**PRELIMINARY SAFETY AND ENVIRONMENTAL  
INFORMATION DOCUMENT**

**VOLUME IV**

**HIGH-TEMPERATURE  
GAS-COOLED REACTORS**

**NONPROLIFERATION ALTERNATIVE SYSTEMS  
ASSESSMENT PROGRAM**

Figure B-1. Gas-turbine HTGR thermal barrier classes.

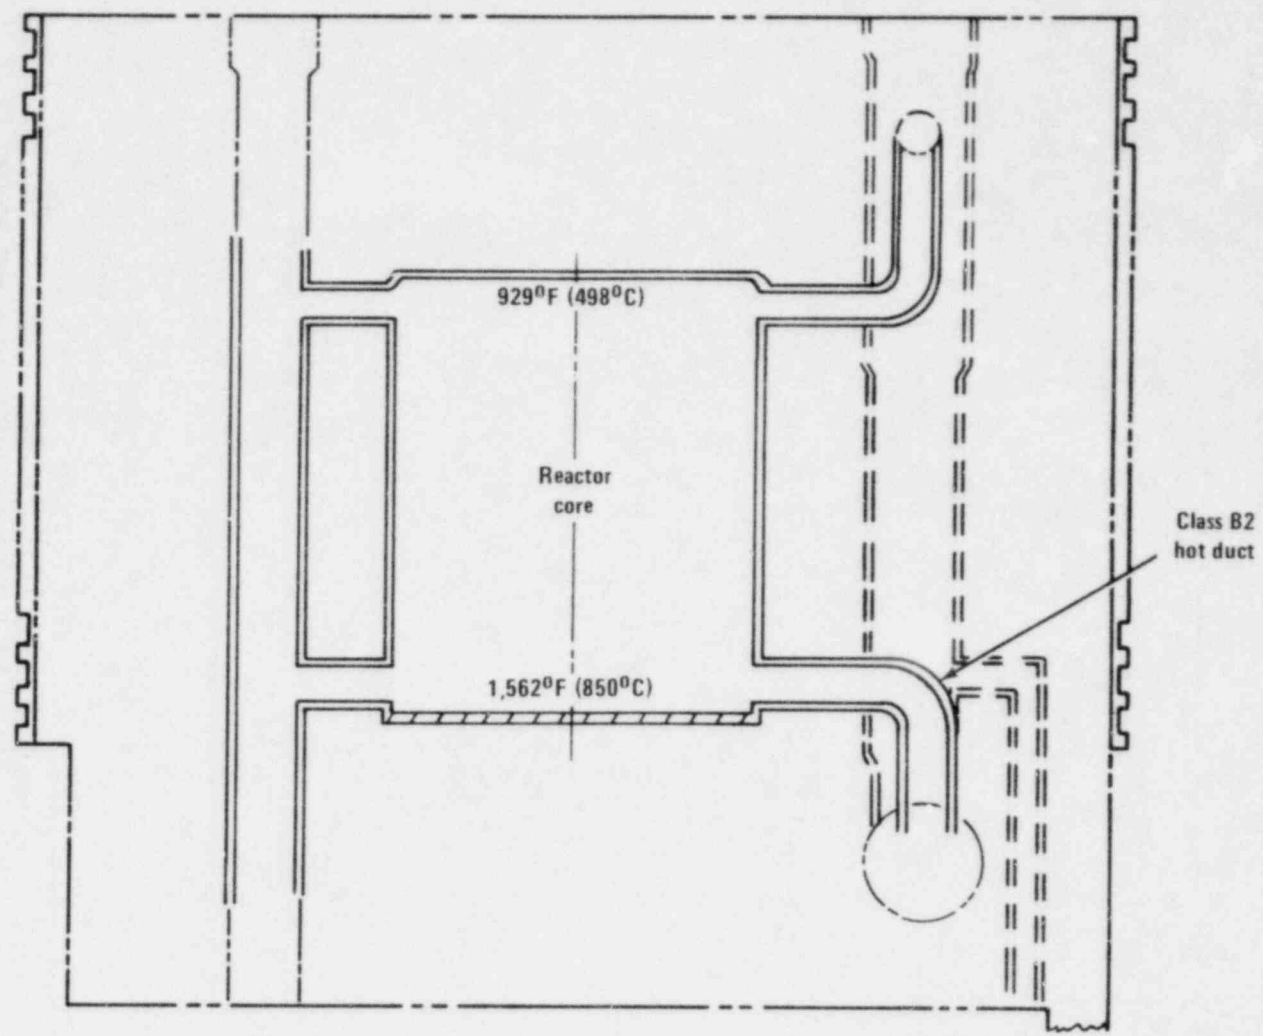
Thermal and mechanical limits are given below for the thermal barriers, reactor internal components, liners, penetrations, closures, the PCRV, the reactor core, and control rods.

Four classes of thermal barrier are used in the HTGR. These classes of thermal barrier are indicated in Figure B-1 as a function of location in the primary coolant loop. Figure B-2 shows a typical Class A, Class B1, and Class B2 thermal barrier arrangement; the design concept for each of these three classes is the same, only the materials are changed. Figure B-3 is an elevation view of a Class C thermal barrier. This concept is significantly different from the other concepts in that hard ceramics are used.

Tables B-1, B-2, B-3, and B-4 give the temperature limits and structural limits for the Class A, B1, B2, and C thermal barrier structural components, respectively. The structural limits for Class A, B1, and B2 thermal barrier apply to metallic components. As indicated in Figure B-2, carbon-carbon is a candidate material for Class B2 thermal barrier. This material is not a metal and not a typical ceramic. Therefore, if this material is used, a new structural criteria will need to be developed. These limits are to be confirmed by research and testing programs.
